COMMITTEE OF ADJUSTMENT

MINOR VARIANCE REPORT

APPLICATION: **CAV A/064/2024**

CAV A/064/2024 - 1333 Sheldon Avenue (West District) (OP Designation: Low Density Residential)

Street View of subject lands – 1333 Sheldon Avenue and the neighbouring dwellings abutting the property to the west at 1337 Sheldon Avenue (left side of photo) and the east at 1331 Sheldon Avenue (right side of photo)

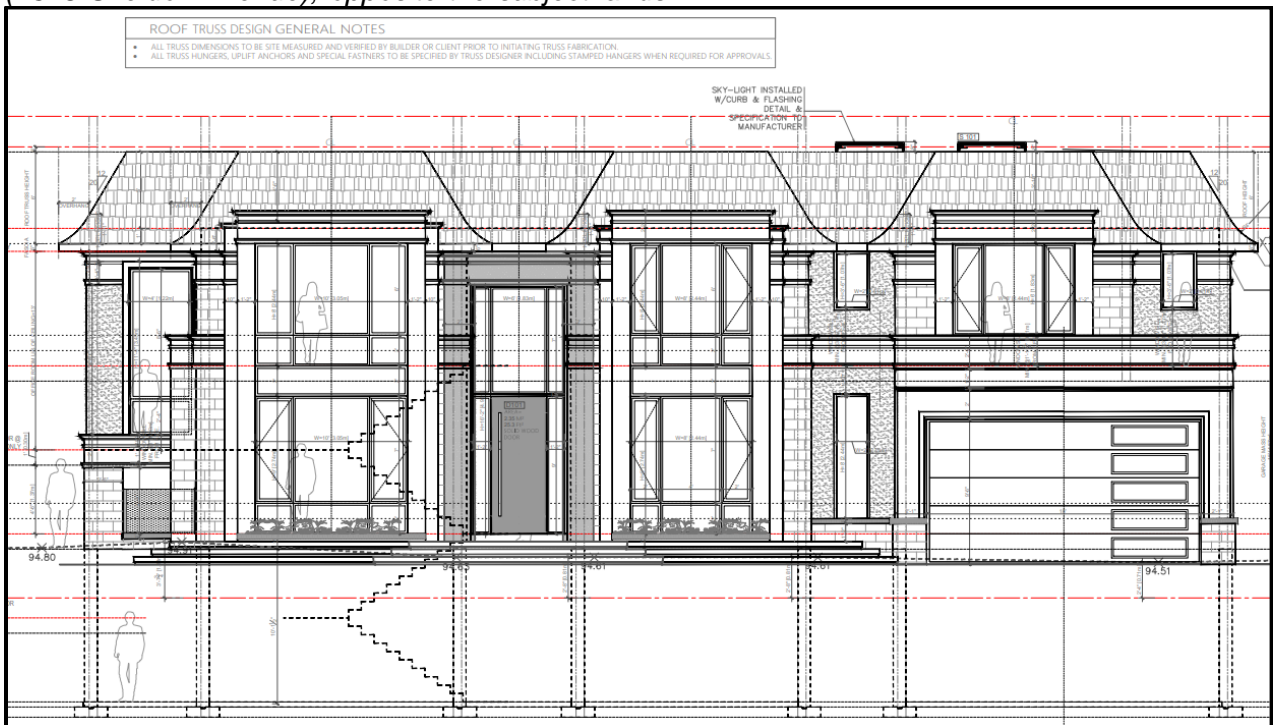
As seen in the photos above, to the immediate east and west of the existing dwelling are two 1-storey bungalows original to the neighbourhood. Across the street from the subject lands is a newer one-and-a-half storey dwelling constructed in 2011.
